Memorandum

Project Name	Taylorville Resource Park		
Memo Topic	Review of PDP (11-Oct-24) "Impacts of Taylorville Resource Park Limited Landfill on Grey District Council Coal Creek Water Supply Intake"		
Memo Date	6 November 2024	Date of Site Visit	
ENGEO Memo No.	03	ENGEO Project No.	26200.000.001
To	Ellen Taylor, TRPL	Copy	TRP Project Team
Author	Lyn Nugent	Reviewer	Dave Robotham

Figure 1: October 2024 Groundwater Contours

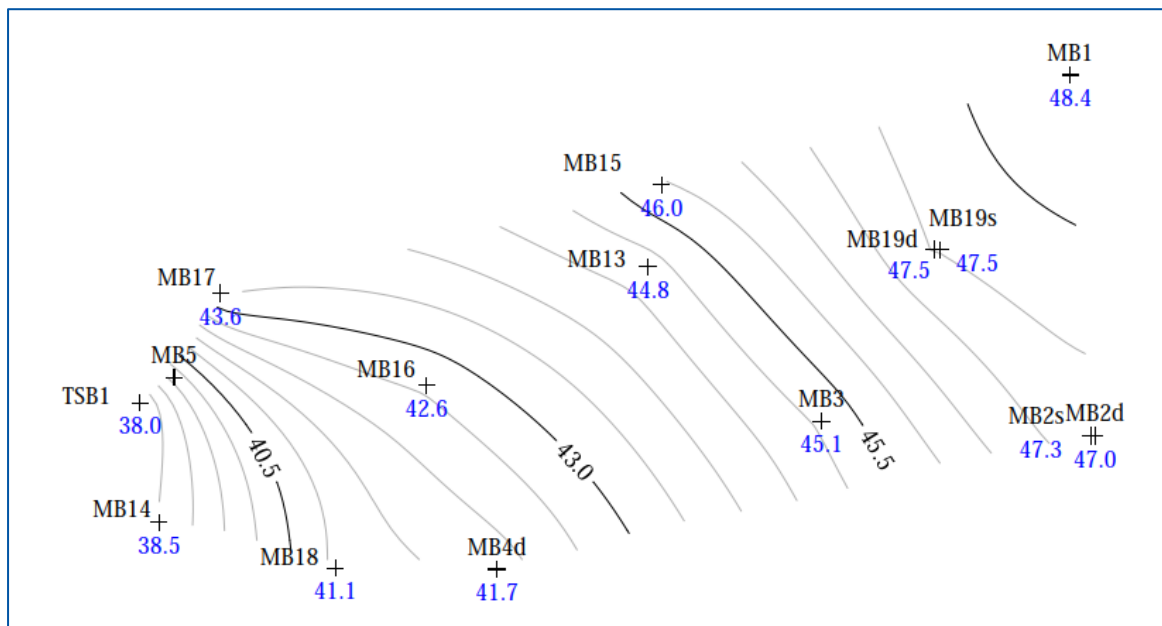
- Groundwater flow is not well constrained and additional bores are required to provide additional groundwater elevation measurement locations to accurately define groundwater flow.

As discussed, the PDP letter was prepared without full a review of the ENGEO (2024) report. The groundwater flow direction measured in July 2024 was discussed in Section 2.3 of that report.

A follow-up groundwater monitoring event was undertaken in October 2024. This included monitoring of eight additional wells (MB13–MB19s/d) that were installed following delivery of the ENGEO (2024) report. Based on depth to groundwater measurements collected from all fourteen on-site monitoring bores, the depth to groundwater ranged from 3.01 m (MB17) to 11.35 m (MB4d) below top of casing. The depth to groundwater was subtracted from the surveyed elevation at the top of the well casing to derive the elevation of the water table (in RL). Based on the calculated groundwater elevations, the general groundwater flow direction is towards the west-southwest with a gradient of 0.018 m/m. A preliminary figure showing groundwater contours is included as Figure 1. The final figure will be included in the upcoming ENGEO revised hydrogeological investigation report.

The October 2024 groundwater flow contours corroborate the flow direction derived from groundwater elevations derived in July 2024. This flow direction is further supported by the inferred slope ($15^\circ - 20^\circ$ to the west-southwest) of the contact between the Pleistocene sandy gravel and the underlying Paleogene Kaiata Formation (Rapahoe Group) mudstone (refer Section 2.2, ENGEO [2024]).
